### Physical Barrier Selection and Design for Existing Pipelines

Document No		530-GD-L-0001			
Rev	Date	Status	Originated/ Custodian	Checked	Approved
0.1	01 Nov 2016	IFR			
			Francis Carroll Engineering Services Manager	Noel Laidlaw Mechanical Systems Specialist	Craig Bonar Manager East Coast Grid Engineering
			[Name] [Position]	[Name] [Position]	[Name] [Position]

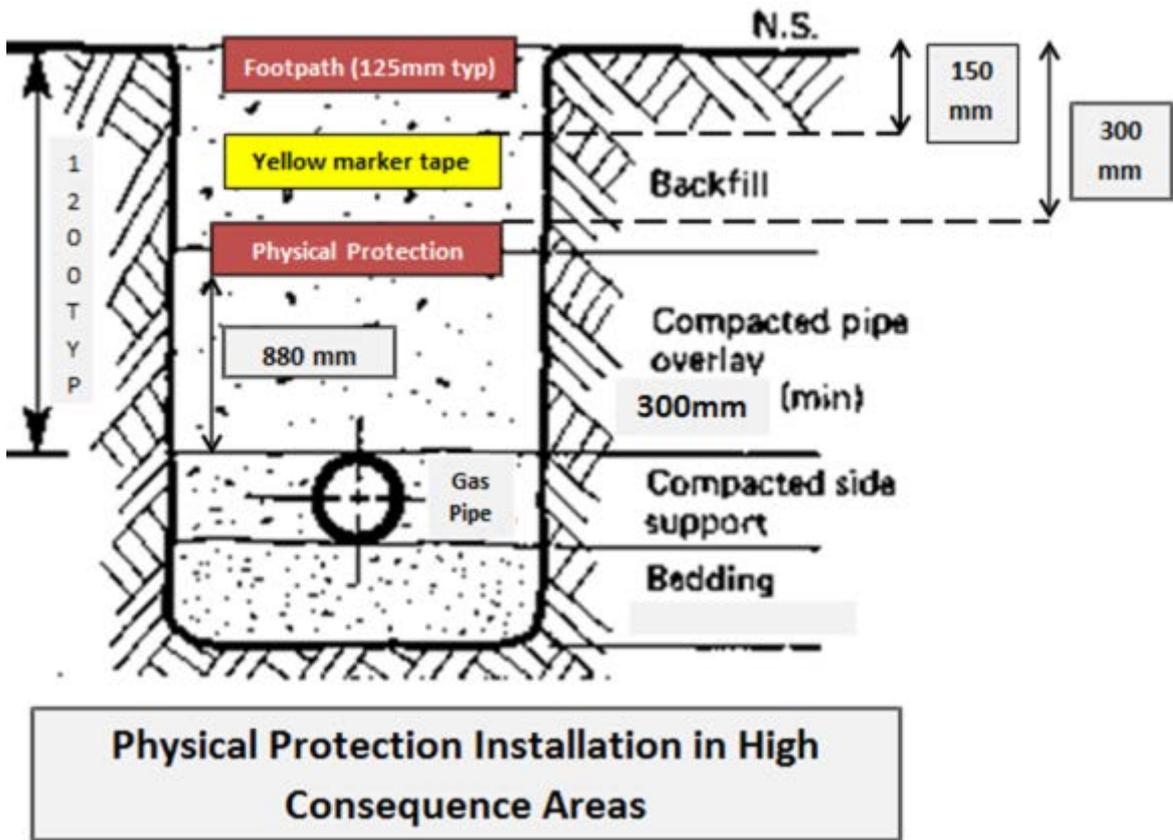
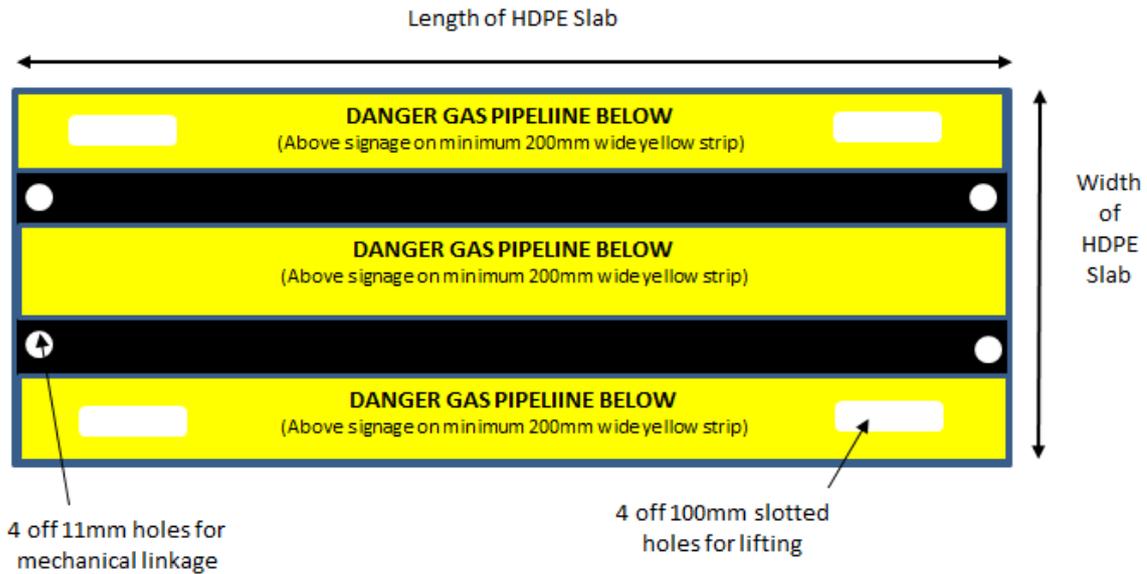
The desktop study component may not pass for pipeline OD > 300mm with 1.2m wide slab. A comment on assessing slab widths for diameters greater than 300mm should be made.
